STAFF RECOMMENDATION

NCPC File No. 6561

FORMER WASHINGTON CONVENTION CENTER SITE INTERIM PARKING LOT 900 9th Street, NW, Washington DC

January 27, 2005

Design Concept

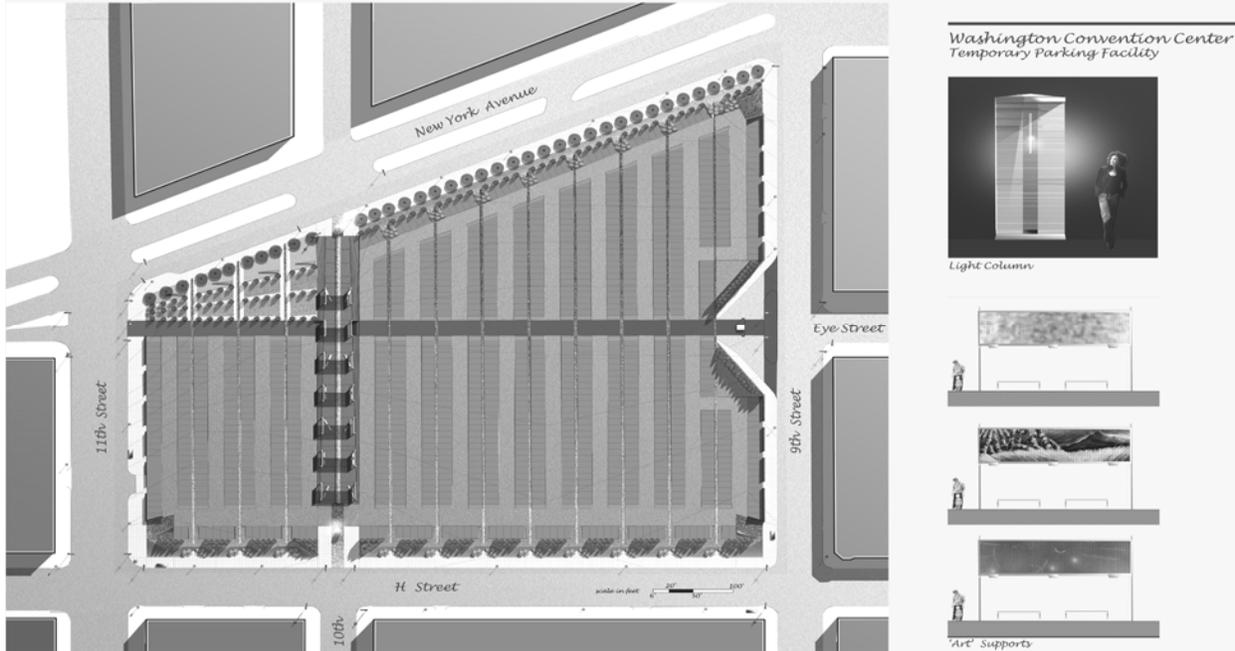
- The submission materials included illustrations that indicated vibrant colors on the vehicle parking areas and primary circulation lane. These vibrant colors in conjunction with parked vehicles that are generally colorful and highly reflective, would be too visually intense for the site. Staff recommends using more subdued colors to define these areas to reduce the overall visual intensity of the 10.5-acre site.

- While the use of artificial turf may reduce maintenance costs, staff is concerned that it may be too unnatural and recommends that the applicant re-evaluate the use of this material. The use of artificial turf is not compatible with the use of natural plant materials in the rain garden and the Federal Reservation at 11th and New York Avenue.

- Explore alternative landscaping treatment using natural plant materials along the pedestrian art corridor between New York Avenue and H Street.

- Use more subdued colors to mark vehicle parking and circulation areas.
